Consultation Response from KC, Highways Development Management
2025/90890 Land at, Yew Tree Road, Birchencliffe, Huddersfield, HD2 2EQ
Variation of conditions 1 (Plans), 2 (Materials), 6 (Landscape Works). 7 (Landscape Management Plan), and 14 (Ecological Design Strategy) of previous permission 2021/94363 for reserved matters application pursuant to outline permission 2018/90151 for erection of 17 dwellings
Date Responded: 14-7-2025 Responding Officer: Mark Berry. Responding Ref: 4-1-50.

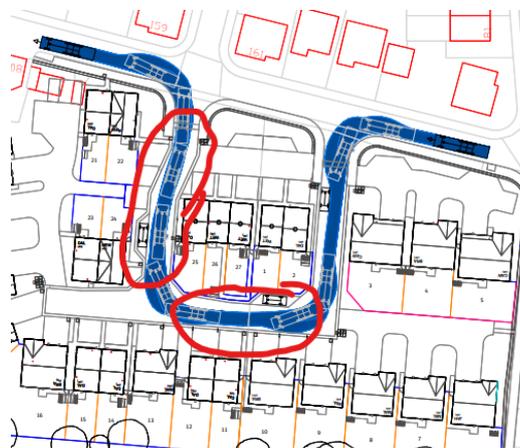
Kirklees require a swept path analysis for an 11.85m in length refuse vehicle indicating how it can pass an on-coming or parked family car throughout the layout. The carriageway will require widening on the bends to enable this manoeuvre. The refuse lorry below does not indicate how it can pass an on-coming car in the areas circled red below which is not acceptable and hence the carriageway will require widening.
